Environmental Impact Report

LDR No. 99-1094
SCH No. 2000011053

SUBJECT: Rancho Encantada Precise Plan. AMENDMENTS to the CITY OF SAN DIEGO PROGRESS GUIDE AND GENERAL PLAN (GPA), PRECISE PLAN, REZONE (RZ), VESTING TENTATIVE MAPS (VTM), PLANNED RESIDENTIAL DEVELOPMENT (PRD) PERMITS, and RESOURCE PROTECTION ORDINANCE (RPO) PERMITS to amend the existing Progress Guide and General Plan to rezone lands from IL-3-1 (formerly M1-A) and IH-2-1 (formerly M2-A) to AR-1-1 (formerly A-1-10), and adopt a Precise Plan for the approximately 2,658-acre Beeler Canyon Future Urbanizing Area (FUA). Separate VTM, PRD, and RPO Permits are proposed for the development of the following parcels: Montecito Subdivision (LDR No. 99-0295), and Sycamore Estates (LDR No. 99-0899). The Montecito Subdivision proposes to grade 3.16 million cubic yards of earth on 153 acres and subdivide a 278-acre site into 317 lots to construct 277 single-family residences; create 36 open space lots totaling 125 acres; and preserve an existing residence on a 1.7-acre lot. The Sycamore Estates project proposes to grade 14.9 million cubic yards of earth on 590 acres and subdivide a 2,132-acre site into 631 lots to construct 557 si

**Figure 3-1
PRECISE PLAN
LAND USE PLAN**

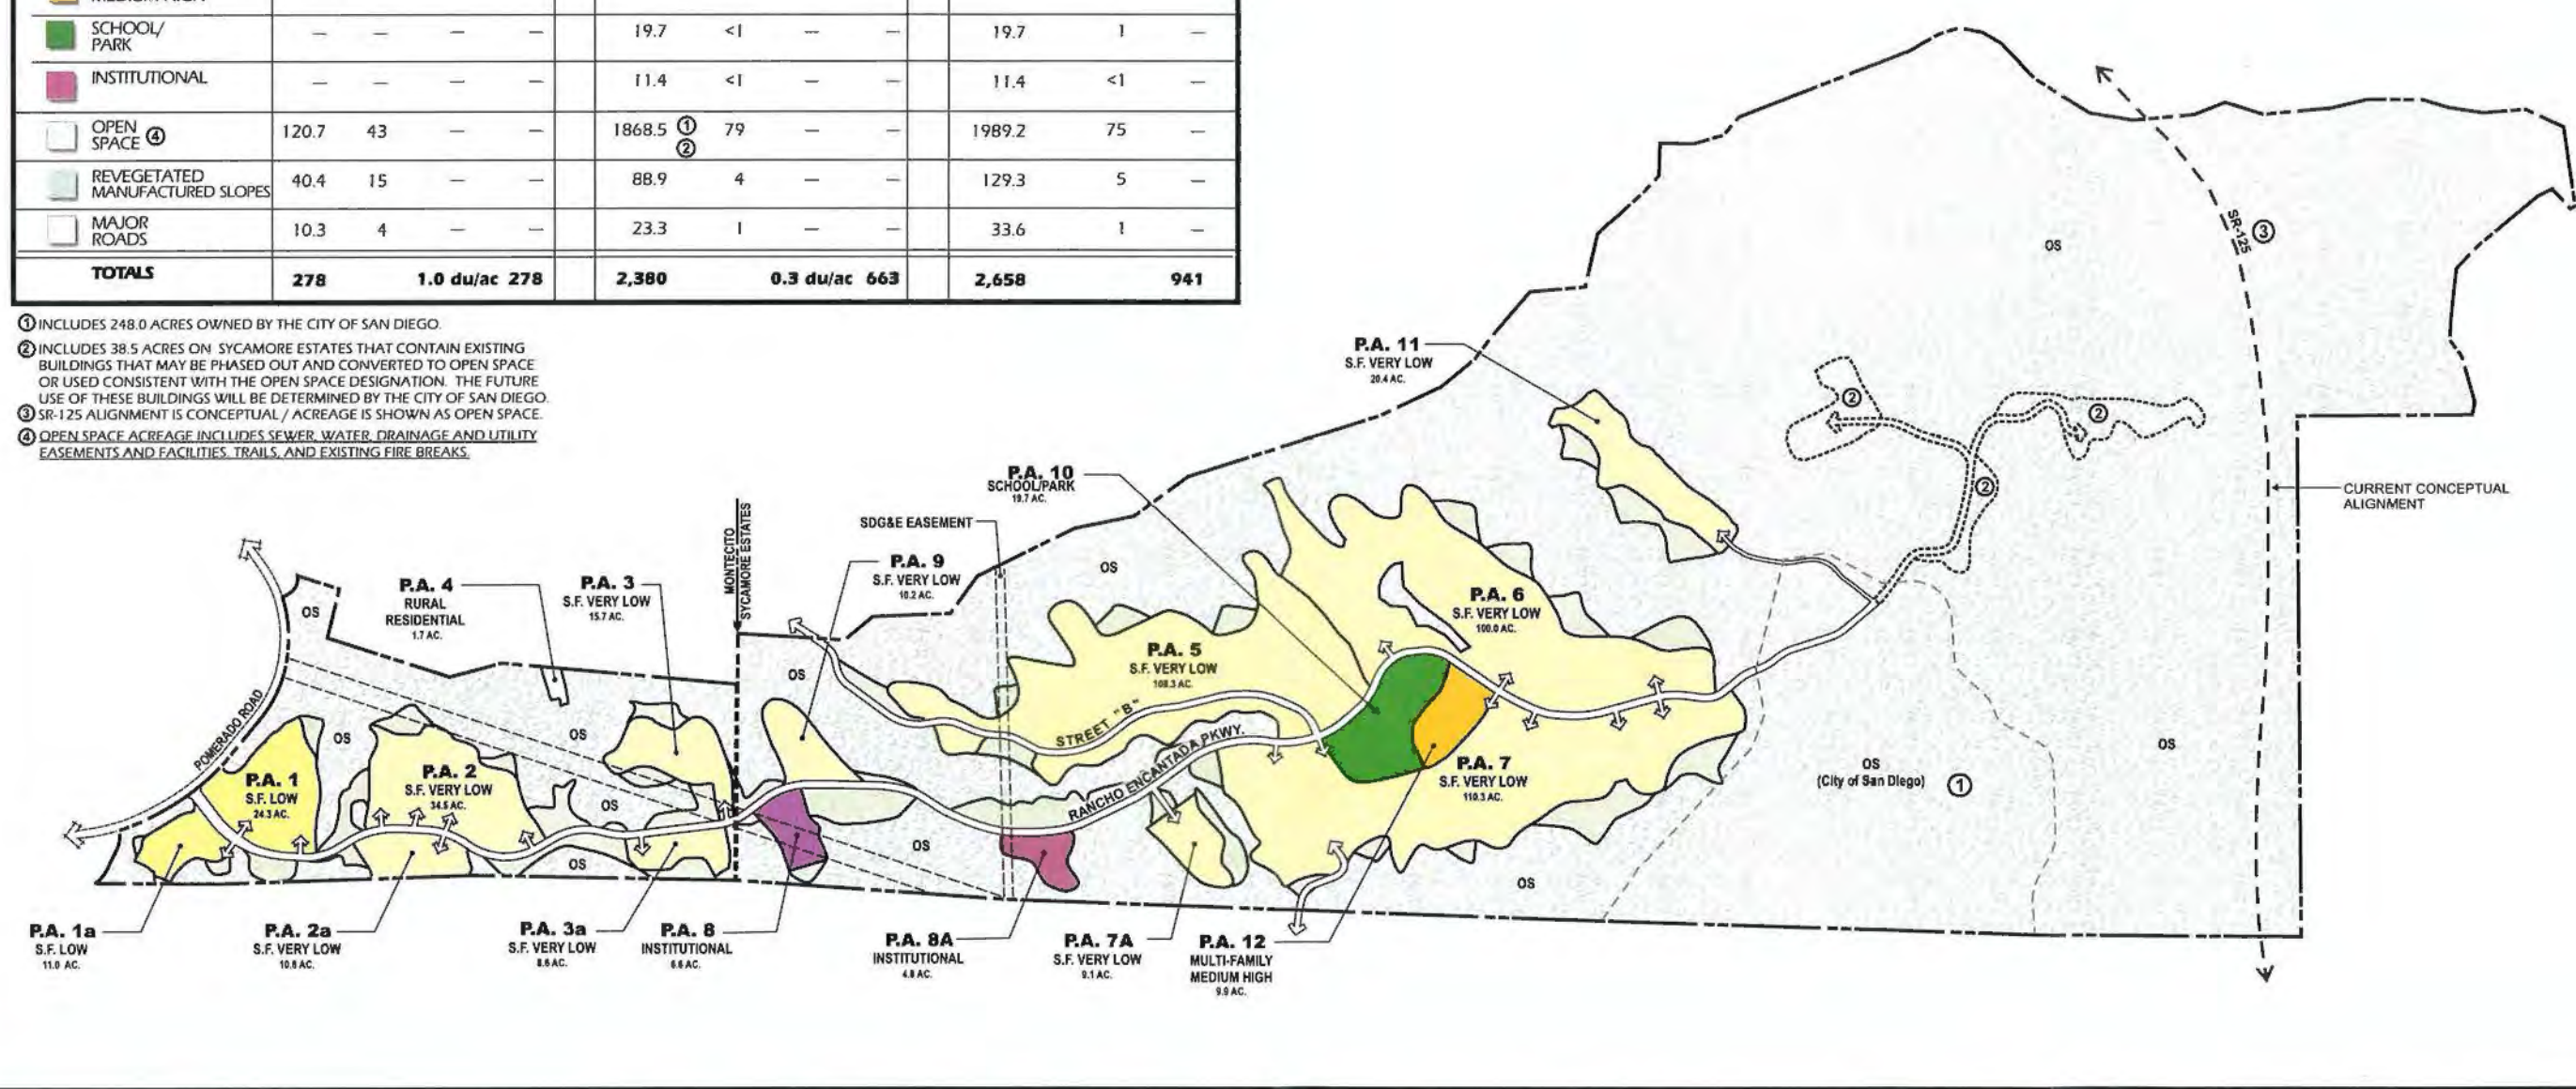
Between Sections 3.2.4, 3.2.5, and figure 3-1, the reader is given the impression that all areas colored "open space green" on figure 3-1 will be natural, undisturbed open space. However, the project's proposals for utility connections including water service, sewer service and drainage, as well as other improvements, will heavily impact the "open space" periphery of development pads. Grading to install such facilities and permanent improvements to maintain access to such facilities such as access roads, will largely compromise surrounding open space, including MSCP-MHCP designated open space. This should be clearly described in Section 3.2.4, and shown on the map figure 3-1. The acreage of open space land to be so compromised should be disclosed.

P. 3-5, figure 3-1 The presentation of dwelling units per acre figures in the Totals row of the "land use abstract" table, is inaccurate as previously stated. This page and similar references in the draft EIR need to be corrected, and a revised draft EIR circulated for public review.

Further, between Sections 3.2.4, 3.2.5, and figure 3-1, the reader is given the impression that all areas colored "open space green" on figure 3-1 will be natural, undisturbed open space. The project's proposals for utility connections including water service, sewer service and drainage, as well as other improvements, will heavily impact the "open space" periphery of development pads. Grading to install such facilities and permanent improvements to maintain access to such facilities such as access roads, will largely compromise surrounding open space, including MSCP-MHCP designated open space. This should be clearly described in Section 3.2.4, and shown on the map figure 3-1. The acreage of open space land to be so compromised should be disclosed.

P. 3-5, figure 3-1: Again, the presentation of dwelling units per acre figures in the Totals row of the "land use abstract" table, is inaccurate and misleading. Not only should the 248 acres of the City-owned parcel be excluded from this calculation; acreage devoted to other land uses, including institutional, the school and park, the 38.5 acres devoted to existing buildings, and the project roadways, should also be excluded, so as not to be counted towards more than one land use. Excluding the MSCP open space area will yield a further, substantially-increased true density figure. This page and similar references in the draft EIR need to be corrected, and a revised draft EIR circulated for public review.

130 The Density columns on the Figure 3-1 Land Use Abstract represent the density range permitted by land use category and are correct as shown. No changes are necessary to the EIR based on this comment and recirculation is not warranted. Also see response number 102.

382 See response number 129. A footnote has been added to Figure 3-1 which states that utility improvements and trails are included in the open space acreage.

**Figure 3-6
PRECISE PLAN
CONCEPTUAL DRAINAGE PLAN**

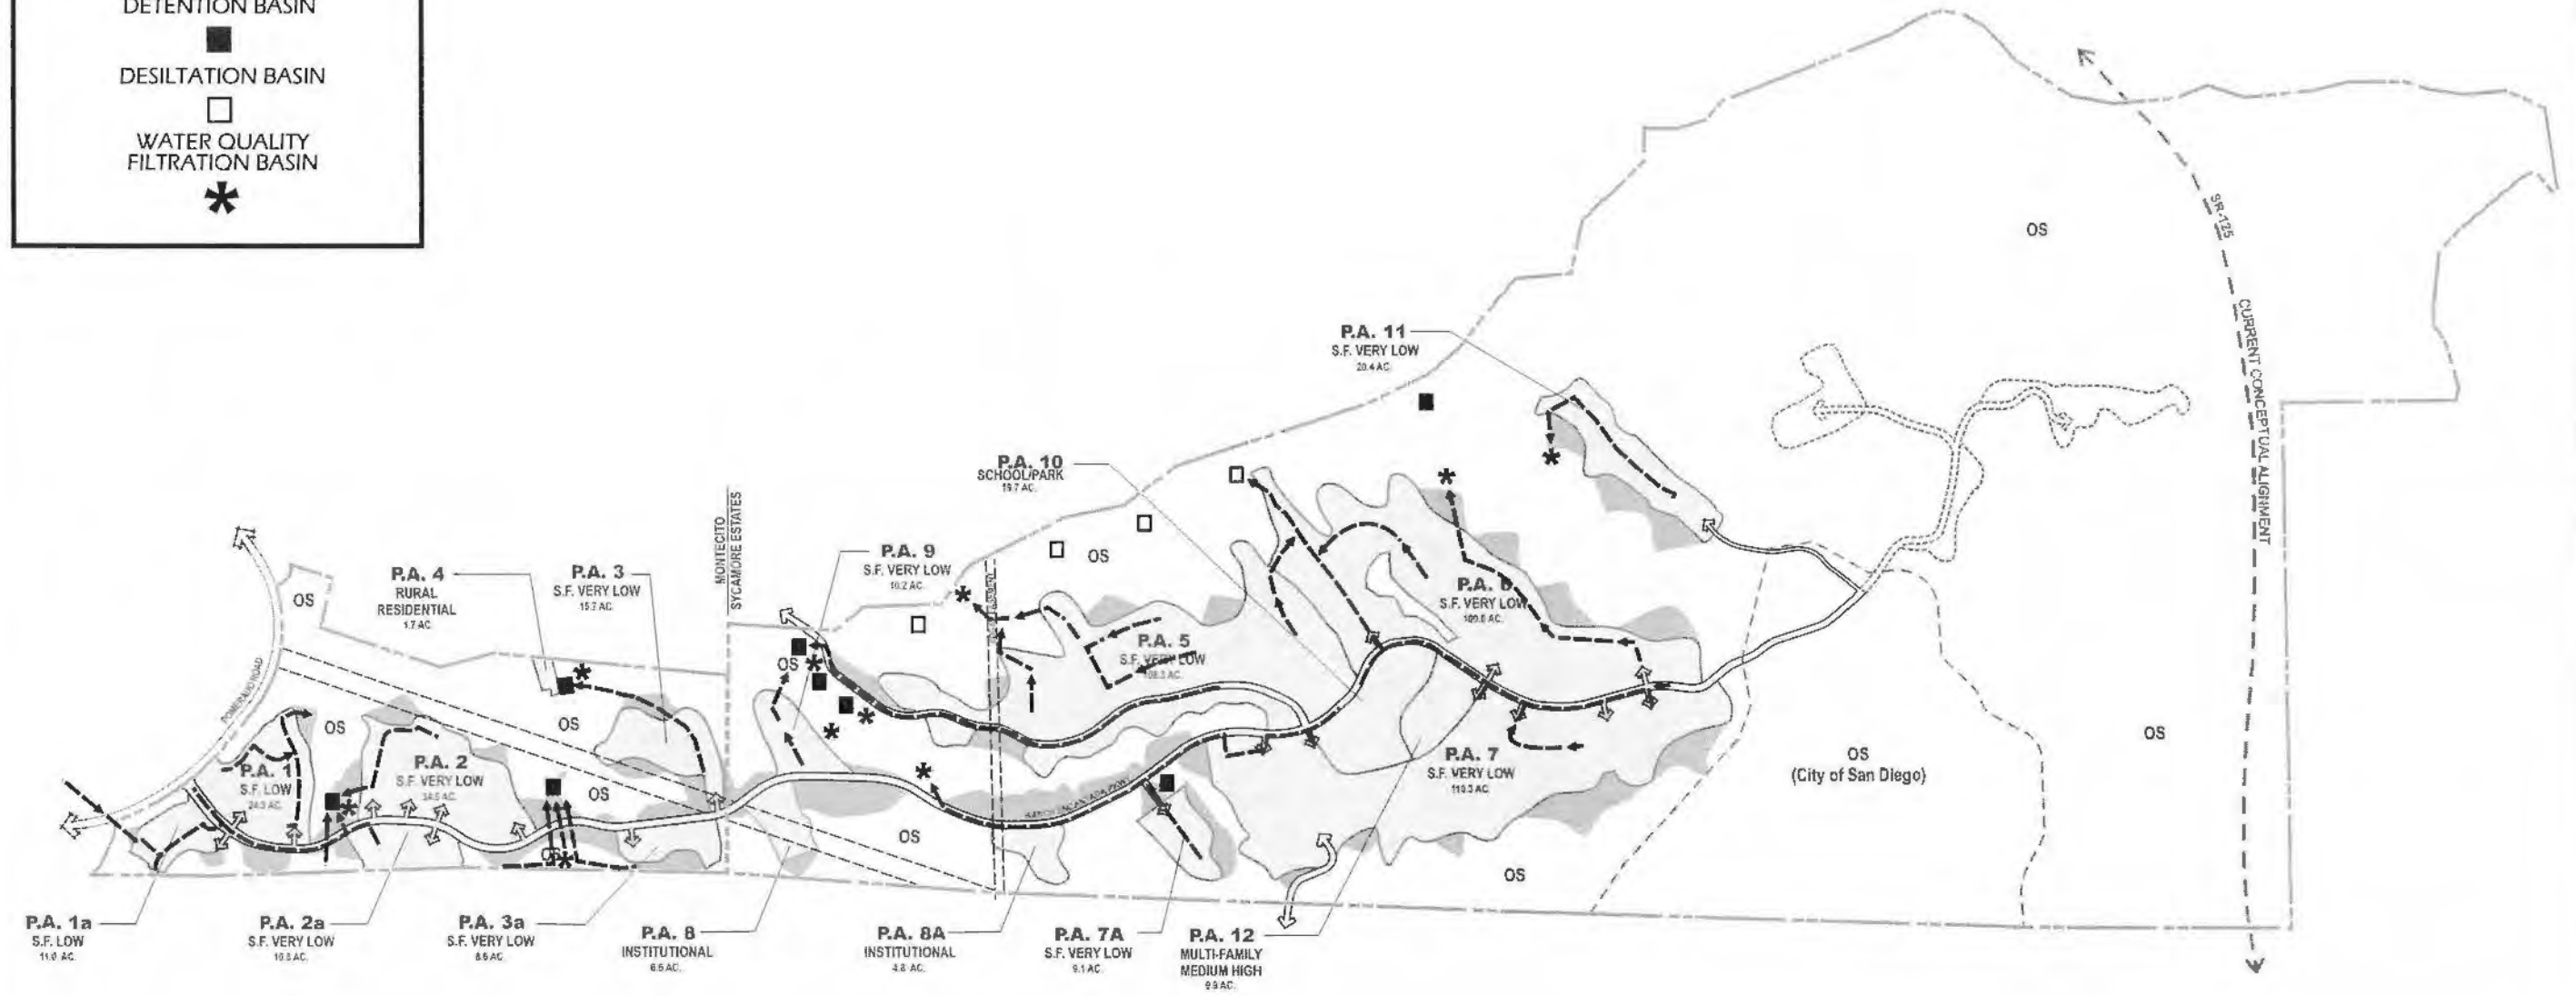
P. 3-10 and 3-15 and figure 3-6, Drainage Plan: Substantial utility facilities off-site of the residential padded areas and within the project "open space" areas will substantially compromise open space integrity. Not only drainage lines/swales, but also graded detention and desiltation basins are proposed. Twelve desiltation and detention basins are indicated on figure 3-6 within open space. However, the extent of grading and brush clearance specifically to accommodate these facilities is not indicated on any graphic, notably, figure 3-1, and a separate delineation of grading (volume and area extent) for these facilities is not disclosed. This should be, including those volumes and extents in open space.

Pp 3-10 and 3-15 and figure 3-6, *Drainage Plan*: Again, substantial utility facilities off-site of the residential padded areas and within the project "open space" areas, will substantially compromise open space integrity. Not only drainage lines/swales, but also graded detention and desiltation basins are proposed. Twelve desiltation and detention basins are indicated on figure 3-6 within open space. However, the extent of grading and brush clearance specifically to accommodate these facilities is not indicated on any graphic, notably, figure 3-1, and a separate delineation of grading (volume and area extent) for these facilities is not disclosed. This should be, including those volumes and extents in open space.

136 See response number 129. As is common practice in long-range planning documents, and as its title implies, the Precise Plan Land Use Plan (Figure 3-1) depicts land uses. It is not appropriate to show proposed drainage infrastructure or brush management areas on the land use plan. Drainage facilities are conceptually shown on Figure 3-6, Precise Plan Conceptual Drainage Plan. The design of these facilities, including the disturbance area required to accommodate them, is shown on Figures 3-8 through 3-16. Brush management areas are shown on Figures 3-9 and 3-14.

Figure 4.3-7
 MONTECITO
 MHPA BOUNDARY ADJUSTMENT

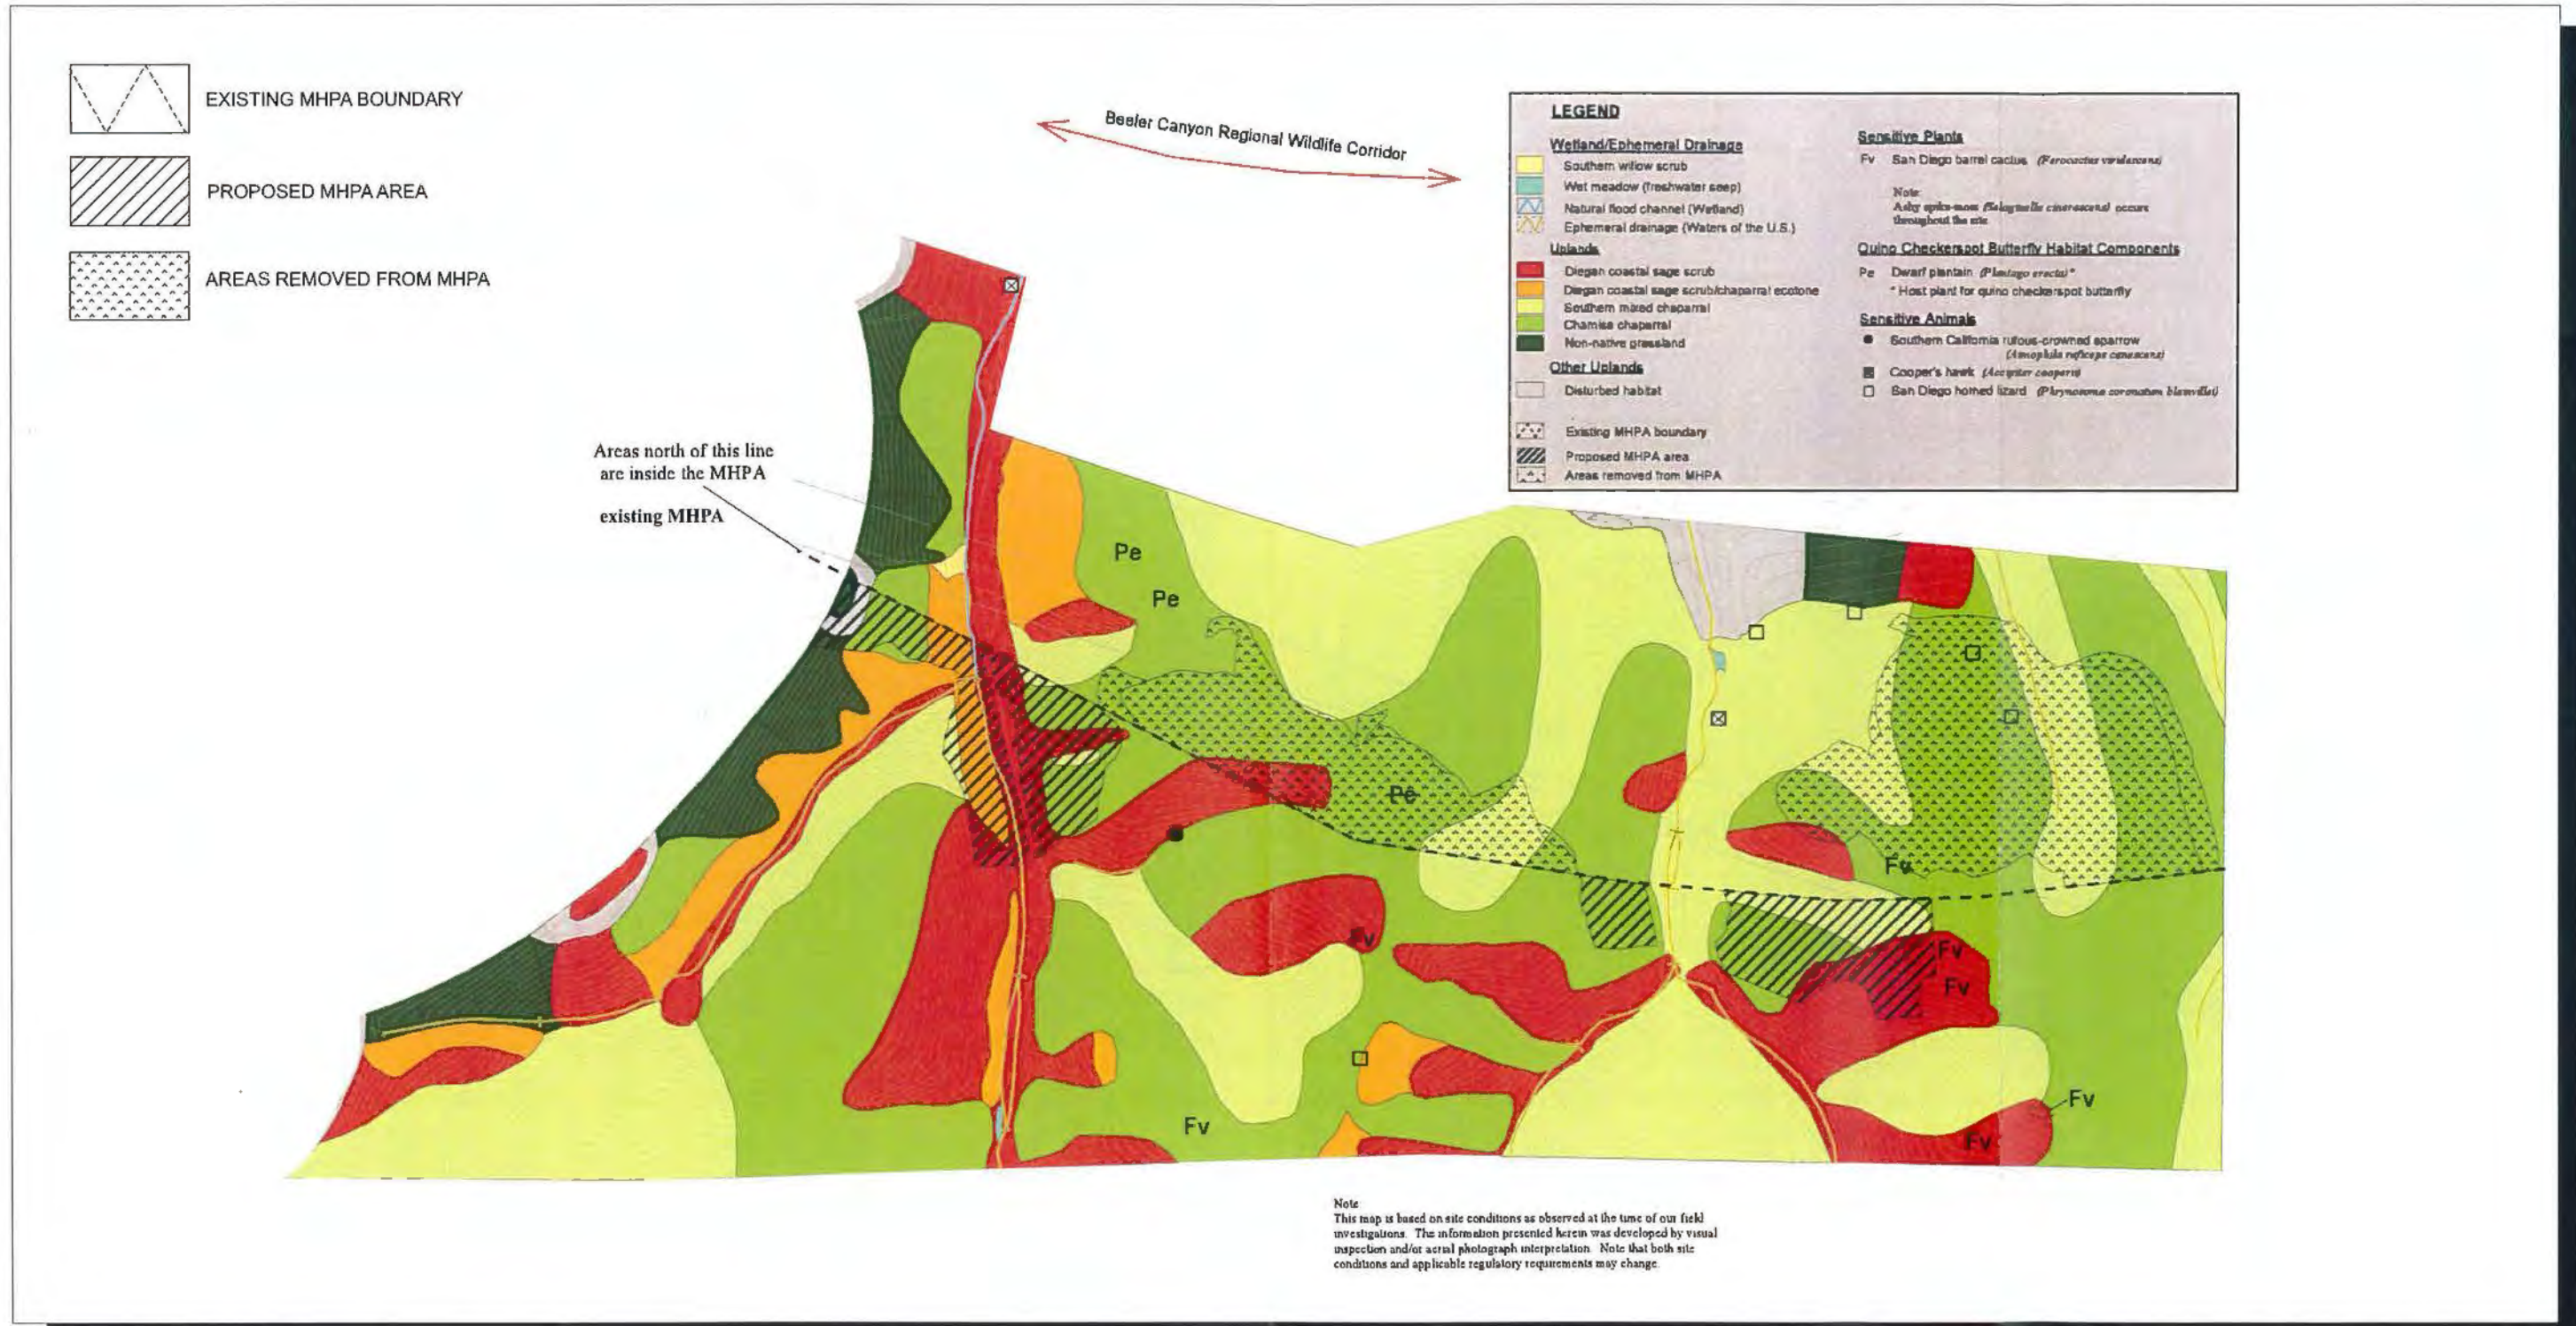
- The text on page 4.3-51 of the biological analysis report indicates that there were no covered species found in area removed from the MHPA or observed in field surveys, yet there is a gnatcatcher sighting shown in Figure 4.3-6 within the proposed development portion of the Montecito project and no discussion of mitigation.

- 75 Figure 4.3-8 represents the Sycamore Estates sub-project site, not the Montecito sub-project site. No gnatcatchers have been observed on the Montecito project site (EIR Figure 4.3-7). One gnatcatcher was observed in an area immediately adjacent to an area being added to the MHPA on the Sycamore Estates project (Figure 4.3-8). Mitigation is included (see mitigation measure 4.3-19).
